Informal document **GRE-77-27**
(77th GRE, 04-07 April 2017,
Agenda item 6 (b))

Status of the IWG VGL

VGL-06-05

Diagram with limit values (left for glare/right for visibility)

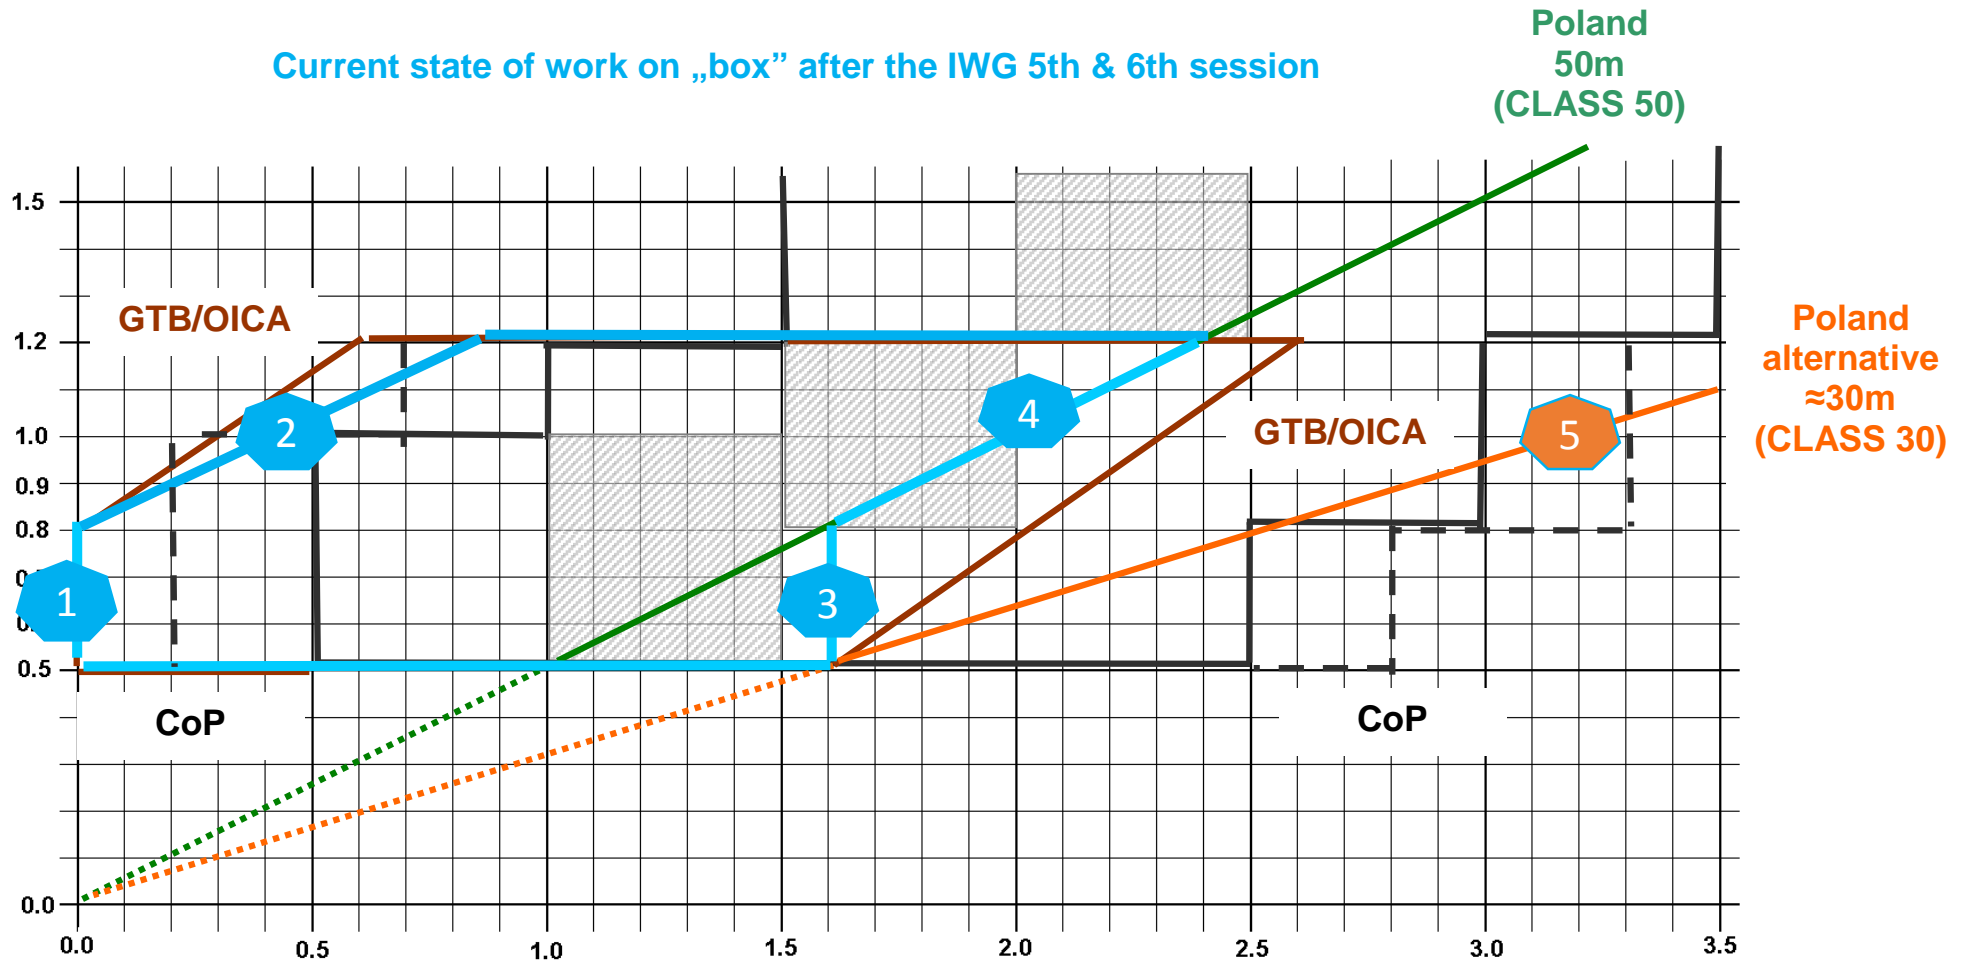
Concerns & expectations by CPs for each part of the diagram → justifications to be prepared for the next meeting

- **LINE 1 - 0.0;0.5 – 0.0;0.8** UK and Poland: Why is necessary to deviate from existing requirement (0.2;0.5 – 0.2;0.8) and assurance not to create glare issues
- **LINE 2 - 0.0;0.8 – 0.85;1.2** Why is necessary to deviate from existing requirement (CoP) and assurance not to create glare issues
- **LINES 3 and 4**
 - **1.6;0.5 – 1.6;0.8** This vertical line was introduced because of the request by the industry to have a variation of 1.6 %. In consequence different mounting heights will led to different road illumination distances. Request for clear justification for minimum 1.6% tolerance area.
 - Expectation of Poland to have the same road illumination distance independently on mounting height (**1.6;0.8 – 2.4;1.2** green line)
- **LINE 5 (orange):** Expectation of Poland to have the same road illumination distance independently on mounting height (**crossing 0;0 – 1.6;0.5**)
